Reply on RC1

Reply on RC2

R-Fig. 1: Time series of wind speed at hub-height from simulation for both cases, AGW and non-AGW, and measurement for the AGW case, AGW (measurement).

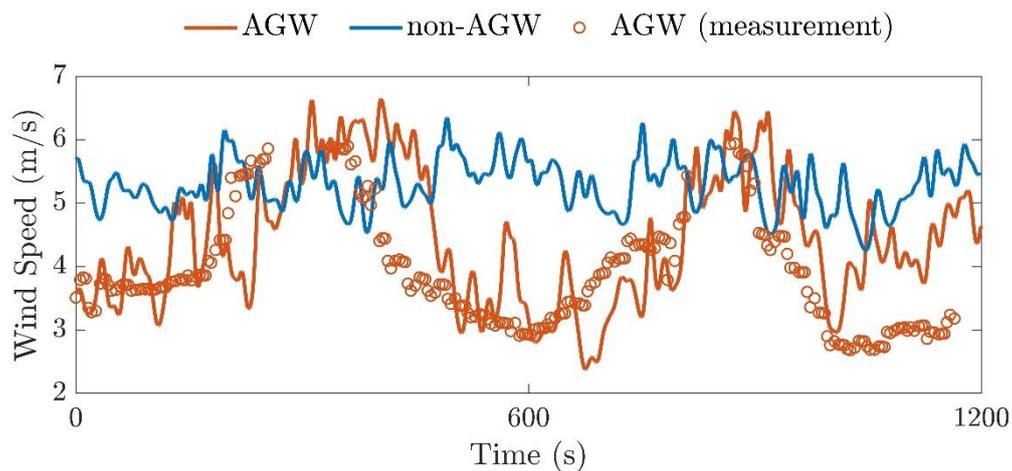
(1) I do not believe that the AGWs shown in Fig. 2 are due to topography, but I also believe that the generation mechanism for the simulated AGWs is not relevant to the work. Unless the authors can provide compelling evidence that the AGWs are terrain-induced, any references stating that the AGWs are a result of topography should be removed or reworded. This starts with the first sentence of the abstract. The authors could state that there are a number of generation mechanisms for AGWs (which is why this is a relevant paper, because they can happen for so many different reasons). Lines 244-245 in the conclusion even briefly discuss how there are other trigger mechanisms.

We thank the reviewer for these constructive comments regarding the generation mechanisms and wave characteristics of the present AGW event. Regarding generation mechanisms, we agree with the reviewer that AGWs can be triggered by various atmospheric phenomena, including frontal systems, thunderstorms, and orographic effects. Regarding wave characteristics, we partially agree with

Although we do not ascertain the exact source of this AGW event, we emphasize that our atmospheric simulation, which is constructed by assimilating lidar measurements into LES model, captures the wind speed characteristics associated with AGWs. In Fig. 3 (renumbered as Fig. 2 in the revised draft), the time-height history of wind speed of AGWs from simulation shows overall agreement with measurement. To further quantify this comparison, we have added R-Fig. 1 (Fig. 3 in the revised draft) presenting the time series of wind speed at hub height. The results demonstrate that our simulation not only reproduces the large-scale oscillations observed in the lidar measurement data, but also resolves smaller-scale turbulence fluctuations. Such detailed turbulence information can provide a reliable inflow condition for turbine simulations.

(iii) We have added R-Fig. 1 as Fig. 3 and added lines 100-102 to clarify imulation-measurement agreement.

R-Fig. 4: Wake (solid lines) and inflow (dashed lines) spectra at downstream 4D (left) and 8D (right) from the single-turbine simulation.

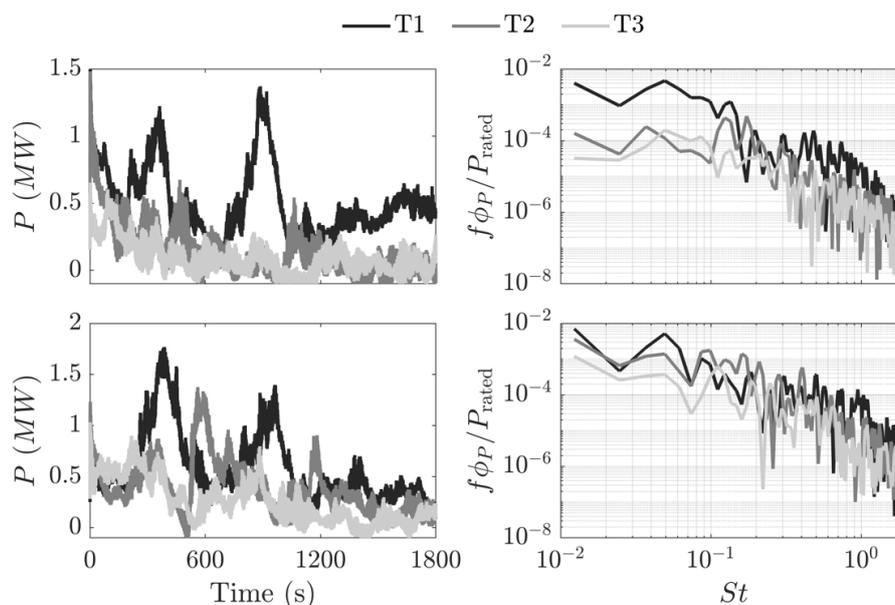
(5) In Section 3.4, why are the turbines only separated by only 4D? This seems to be quite a small separation distance. In Fig. 2, the propagation direction of the AGWs is to the northeast and the separation distances look quite large for the wind farms for that wind direction. The only time 4D would be appropriate would be for a due east or due west AGW propagation direction. Ultimately, the findings in this subsection are quite insightful and I feel like it would be very helpful to see a similar setup but with further separation distances.

Also, considering that attenuation is discussed in this section, more plots of spectra are needed. It would be nice to see the TKE spectra for the inflow representing downwind turbines or even for just the power signal. Then the attenuation can be quantified.

R-Fig. 4 shows TKE spectra for inflow region (dotted lines) and downstream 4D (left) and 8D (right) wake region (solid lines) from the single-turbine simulation. In both AGW and non-AGW cases, the wake spectra exhibit a dominant peak at $St \approx 0.3$. Such a frequency peak arises from a convective shear-instability mechanism that dominates far-wake dynamics, which generates turbulent kinetic

(i) We have added 8D wake spectra for the single-turbine simulation in Fig. 8 (as also shown in R-Fig. 4) and discussed the downstream evolution of wake spectra in lines 194-195.

'For both the AGW and non-AGW cases, such a frequency peak becomes less prominent in 8D downstream, because wake recovery has largely weakened shear instabilities at this region.'

R-Fig. 1: Three velocity components of AGWs at site A (left) and H (right).

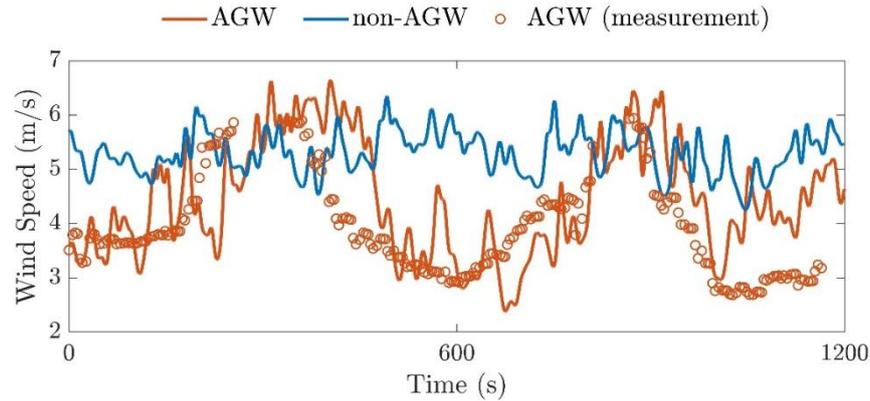
(1) Extent to which the chosen interval represents flow at the AWAKEN site and more generally. Source of data should be given (line 54). The paper identifies use of location A1 and of 08 June 2023 only with the justification that the vertical extent of the gravity wave spans the rotor layer of the wind farm. It would help the reader to show how often these types of condition occur at the AWAKEN site - if only very rarely then is this relevant for design?, if regularly then what range of AGW vertical extents occur? were similar observations (phase lagged) obtained at down-wind sites (e.g. H on Figure 1 map) or does vertical extent differ over the streamwise spacing between turbine rows? More generally atmospheric gravity waves can occur at other sites and locations so some discussion on how the conditions represent AGW conditions at wind farm sites more generally (e.g. in terms of ABL thickness and AGW wavelength - mentioned to be 2 km in LES (line 176), compared to 2.5-3 km measured (line 58)? - and amplitude, not only site roughness which is not the only important factor between sites).

In June 2023, four AGW events with similar wave periods of approximately 600 s were observed. Their vertical extent ranged from the surface up to ~ 3 km above ground level. R-Fig. 1 shows the time-height evolution of the three velocity components for the June 8 event, which is the focus of our study. In the vertical velocity component, similar large-scale wavy oscillations are observed at site A (upstream of the wind farm) and site H (downstream). Such transient atmospheric

(ii) We have added the source of AGW data in lines 54-56.

R-Fig. 2: Time series of wind speed at hub-height from simulation for both cases, AGW and non-AGW, and measurement for the AGW case, AGW (measurement).

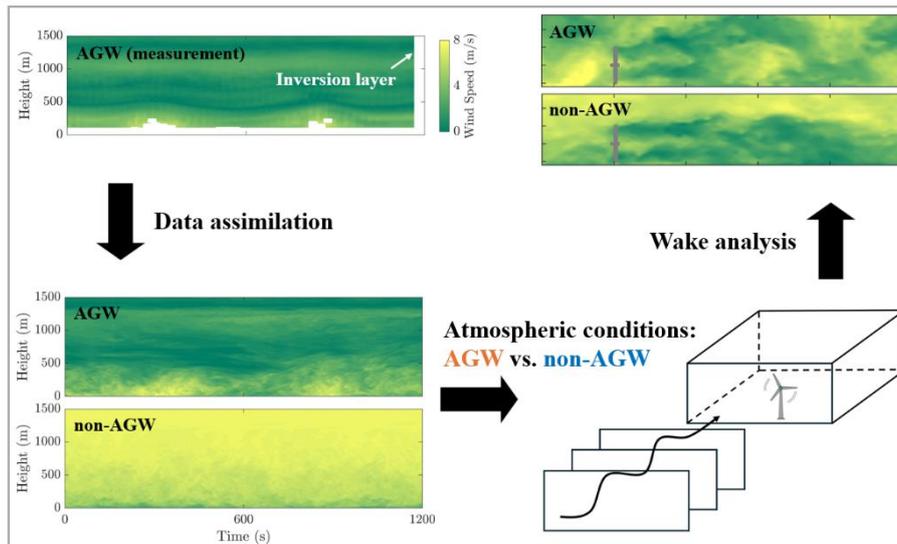
(2) Extent to which the indirect profile assimilation method reproduces the LIDAR measurements of the selected AGW event. The three frames shown on left hand side of Figure 3 compare LIDAR measurements of time varying onset velocity to the simulated conditions. Lines 94-96 comment that “the present LES not only captures the low-frequency wind speed oscillations by the AGW event but also resolves turbulence structures with higher spatio-temporal resolution”. Whilst the simulation seems to capture the period of the selected AGW event there seem to be other differences that are not mentioned; for example the LES shows larger maximum velocity, possibly larger minimum velocity, change of turbulence over $0.5 < \text{height} < 1$ during 06:00 to 07:00 (approx). These need to be critically assessed, particularly in the context of line 39-40 “it is unclear whether LES driven by field measurements can accurately capture transient atmospheric phenomena like AGWs”. A quantitative comparison is needed of the measured and simulated conditions. Comparison of profiles - of velocity, turbulence, potential temperature - at specific time-steps during the AGW event would provide greater clarity. There should also be discussion on whether these AGW event predictions can be considered to be mesh independent and sub-grid model independent.

We agree with the reviewer that our simulation should be validated against measurement data in a more quantitative manner. In Fig. 3 (renumbered as Fig. 2 in the revised manuscript), the simulated AGW wind-speed time-height history shows good overall agreement with the AWAKEN lidar measurements. To further quantify this comparison, we have added R-Fig. 2 (Fig. 3 in the revised manuscript), which shows the hub-height wind-speed time series. The results indicate that our simulation not only captures the large-scale wavy oscillations observed in the measurements, but also resolves smaller-scale turbulence fluctuations. This detailed turbulence information provides a reliable inflow condition for turbine simulations. We did not compute spectra because the measurement data contain missing time steps and are unevenly spaced in time.

We have added Fig.3 (herein R-Fig. 2) and lines 100-102 to clarify the simulation-measurement agreement.

R-Fig. 4: Time history of spanwise (left) and vertical (right) wake centers for AGW and non-AGW cases.

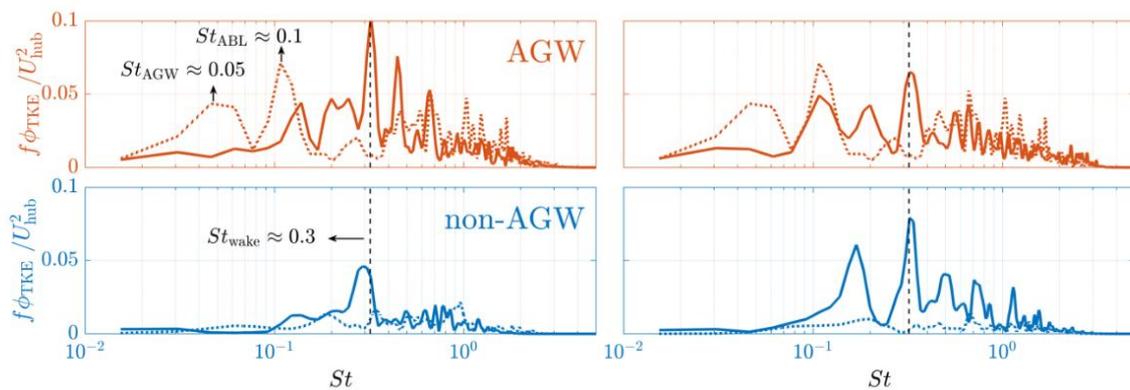
(6) Meandering results. The analysis focuses on the streamwise increase of amplitude of meandering of the wake center. To relate the observed variations to the two mechanisms identified (lines 143-145) it would be helpful to show that this meandering of wake center is occurring at the AGW period (~10 mins as Fig 3?), and to show the turbulence length-scales (which are not currently stated in the manuscript), or corresponding time-scales, for each case.

We plot R-Fig. 4 to show the time history of the spanwise (left) and vertical (right) wake center for both AGW and non-AGW cases during the AGW event. The wake center locations are obtained using a two-dimensional Gaussian fit to the instantaneous wake profile at six rotor diameters downstream. Gaps appear at

(i) We have added clarification on large-scale wake center deflections in lines 143-147.

R-Fig. 5: Wake (solid lines) and inflow (dashed lines) spectra at downstream 4D (left) and 8D (right) from the single-turbine simulation.

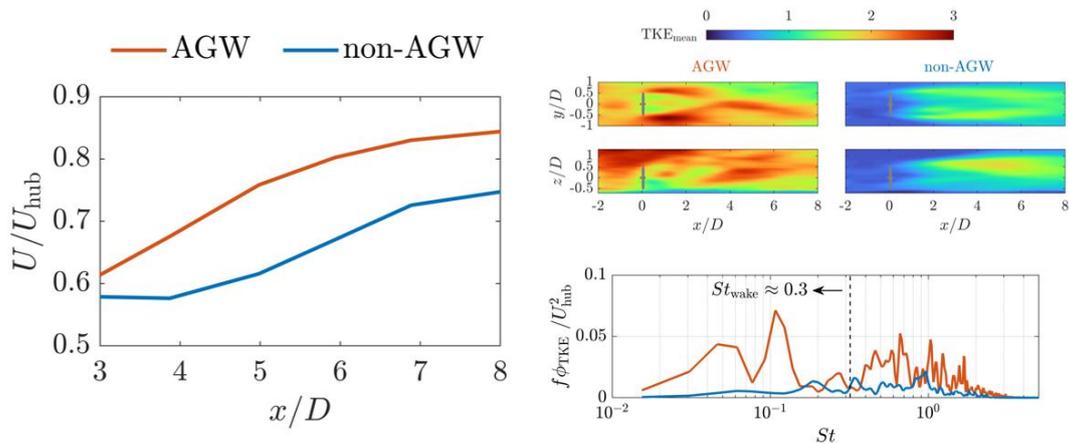
(7) TKE spectra analysis. This is interesting, particularly the peak sustained at Strouhal Number ~ 0.3 . However, the lack of peak at $St \sim 0.05$ in the wake in AGW case seems to indicate that there are not variations in the wake at the AGW period; does this affect line 141-142? Could the same type of spectra be shown for 8D also to better understand whether the same spectral content persists as the amplitude of meandering increases into the far wake? Is there any explanation available for the higher harmonics observed in AGW case?

We show in R-Fig. 5 the spectra of wake (solid lines) and inflow (dashed lines) at 4D (left) and 8D (right) downstream from the single-turbine simulation. In both AGW and non-AGW cases, the wake spectra exhibit a dominant peak at $St \approx 0.3$. Such a frequency peak arises from a convective shear-instability mechanism that dominates far-wake dynamics, which generates turbulent kinetic energy at $0.1 < St < 1$. In the AGW case, the low-frequency inflow peaks ($St \approx 0.05$ and $St \approx 0.1$), shifts to a higher-frequency peak at $St \approx 0.3$ at 4D downstream. This peak becomes less pronounced at 8D downstream as wake recovery weakens shear instabilities.

We have added 8D wake spectra from single-turbine simulation in Fig. 8 (as also shown in R-Fig. 5) and discussed the downstream evolution of wake spectra in lines 194-195.

R-Fig. 6: Mean streamwise wake deficit along the turbine centerline (left). Wake TKE contours (top-right). Inflow spectra (bottom-right).

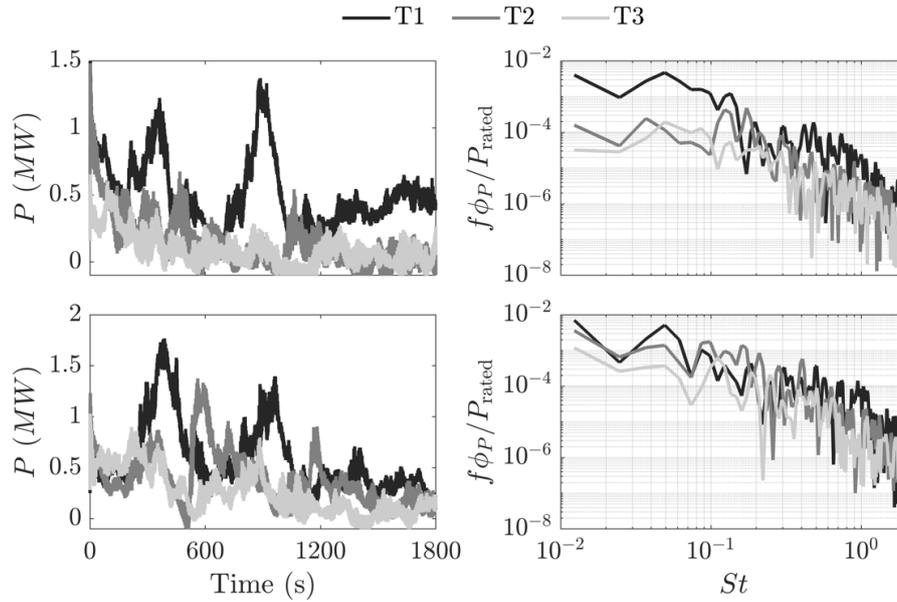
(8) Wake velocity recovery. As noted on line 199 the distance to the maximum velocity deficit differs between the AGW and non-AGW cases. It is not however shown that the wake form is Gaussian at this point. The points on ‘faster recovery of the mean wake of the AGW’ should relate to the distances after this near-wake region. Over that range the AGW wake recovery is faster but it would be useful to bring out this rate of recovery of velocity more clearly. Differences of wake recovery are attributed to two mechanisms: i) stronger wake meandering due to larger-scale turbulent structures, and ii) higher value of TKE in the AGW case. The earlier sections should be modified to support these statements quantitatively including clarification of: the scales of turbulent structures in the onset flows, that the wake meandering is at the AGW periods, the value of TKE of the non-AGW onset flow.

We agree with the reviewer’s suggestion and have replotted Fig. 10 (also shown as the left panel of R-Fig. 6) to illustrate the rate of wake recovery in the far-wake region. The far wake is defined as the region where the spanwise wake profile becomes Gaussian. Based on the mean velocity contours in Fig. 9, we identify $x/D > 3$ as the far-wake region. In this region, the AGW case exhibits a higher recovery rate than the non-AGW case.

(i) We have reprinted Fig. 10 in the original draft with shorter streamwise extent, and rearranged it to make it the right panel of Fig. 7 in the revised draft.

(ii) We have rewritten the discussion on the reasons for faster wake recovery in lines 220-224.
